Town of Payson – Pre Scoping McLane/Longhorn Intersection (Construct New Round-about)

PRELIMINARY SCOPING REPORT

PRE-SCOPING FIELD REVIEW REPORT ROUNDABOUT (Longhorn & McLane) PAYSON

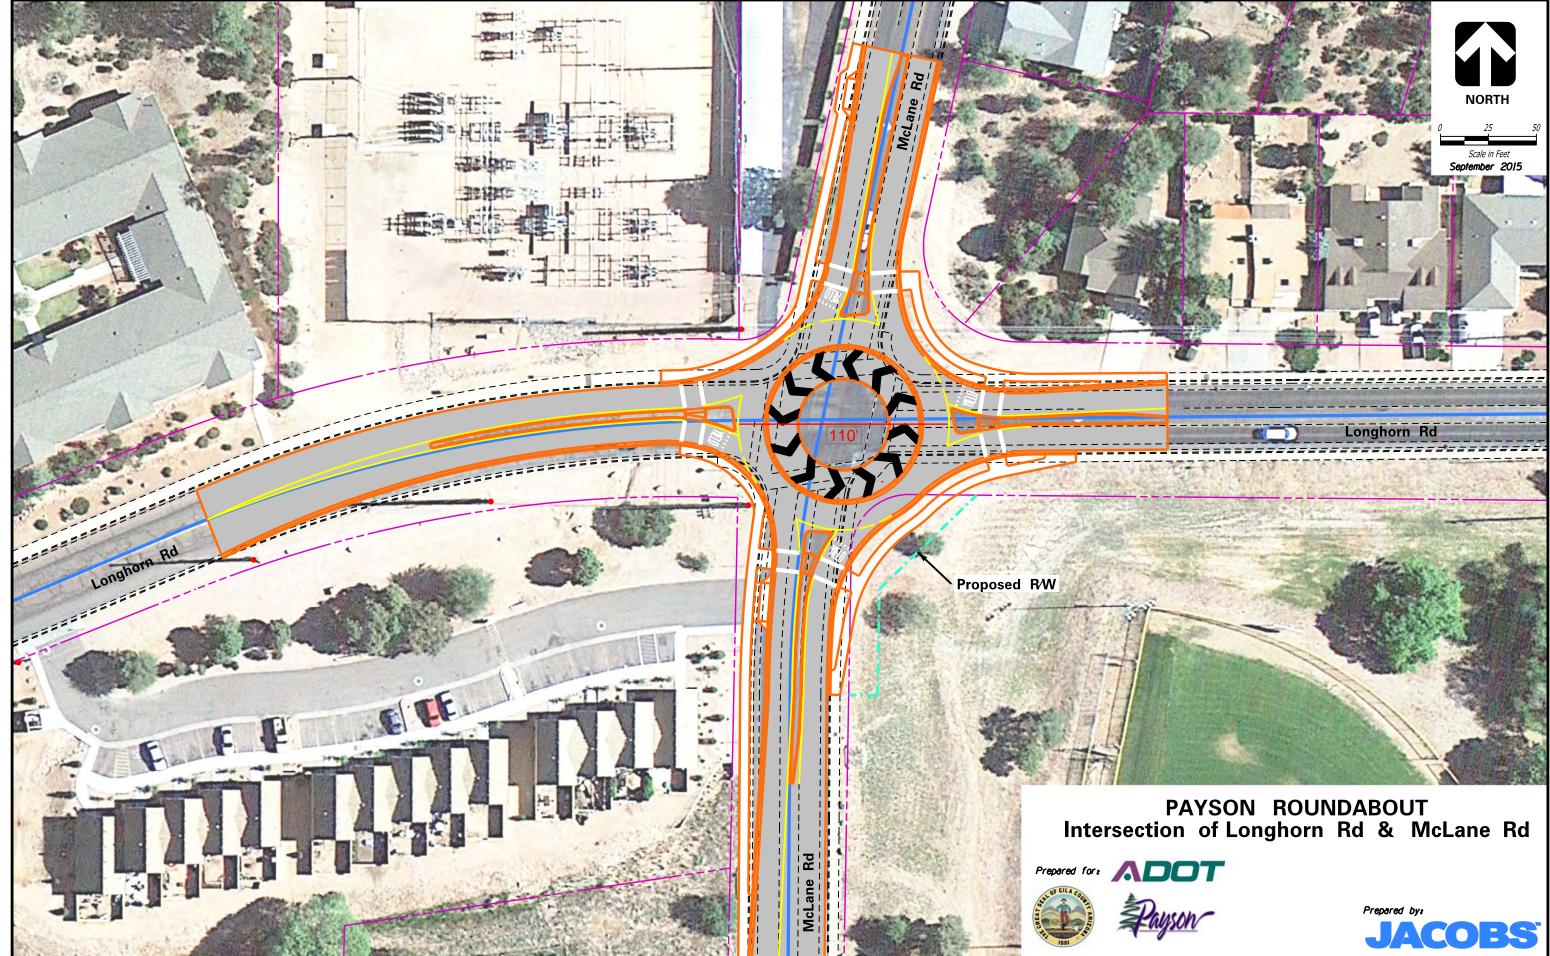
Town of Payson Comments: Please increase roundabout diameter 10' to 110'. Please retain fire lane access to mini storage.

Consider shortening center divider medians and curb and sidewalk improvements, the speed limit is only 25mph, the less expensive this project is the easier it will be to initiate. Consider if the inner concrete chevron circle is necessary in this application. 2019 design \$189k, 2023 construction \$424k, 2024 construction \$124k and we will propose \$262k construction 2025. Is there an efficient method to make the construction funds available in a single year? Can a left out of condominiums be considered?

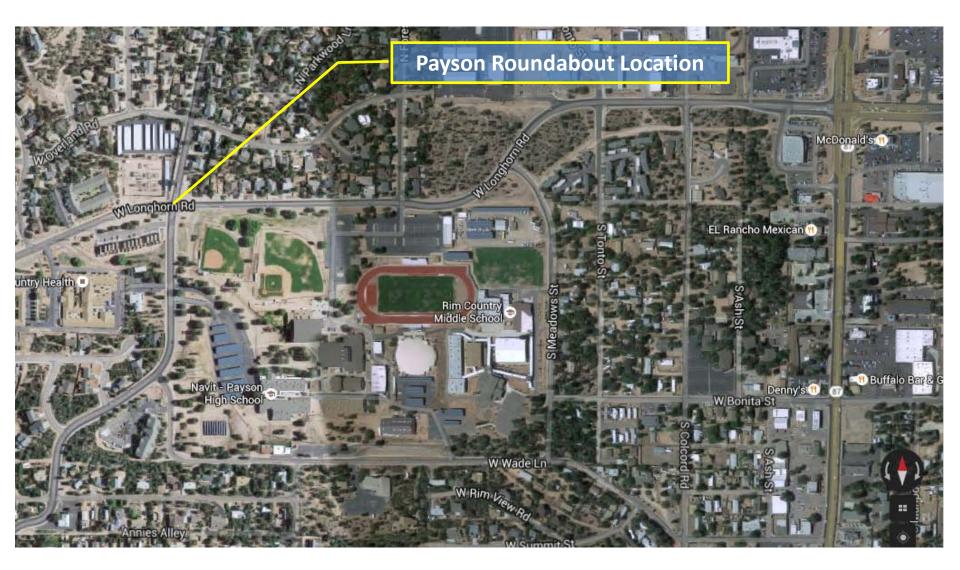
FHWA comment (Kimberly Utley) 8/17/15: If possible, suggest moving secondary access here, to allow for better maneuvering in and out of the storage property. I believe this would also eliminate the Rightin/Right-out only since it would be beyond the proposed median. It also moves it further away from the roundabout.
